Spectralink 76x0- and 77x0-Series

Release Notes Q3, 2016

Firmware Version PCS 16C

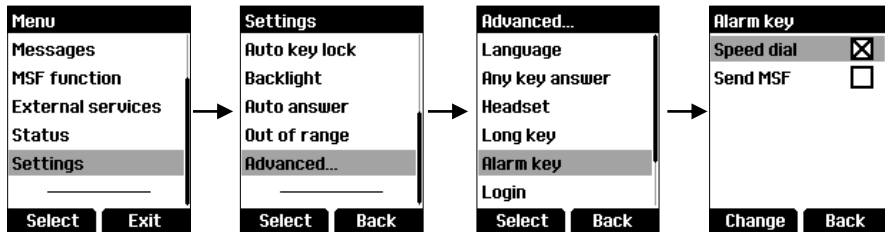
- The built-in wired headset amplifier⁴ can be configured using the handset menu, see screen dumps below. The selectable amplification range spans from -12dB to +18dB.

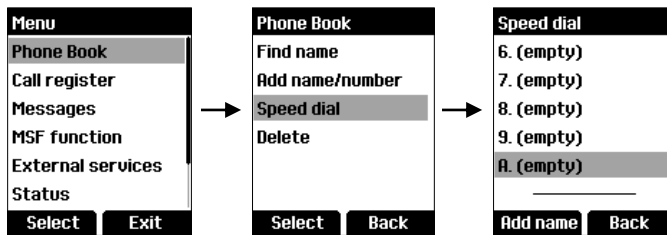
- An entry in the phone book can be assigned to a long key press on the alarm key. First the alarm key must be configured to use speed dial, see below.

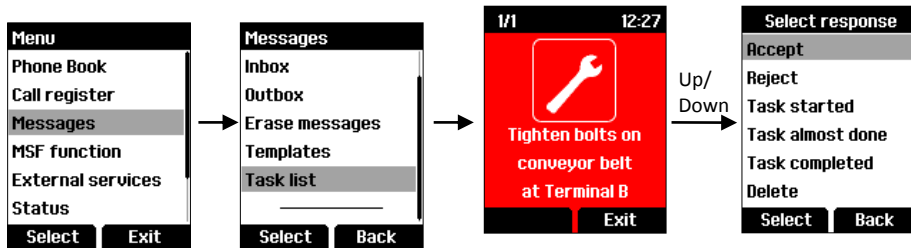
Then speed dial entry "A" must be assigned by selecting Add name:
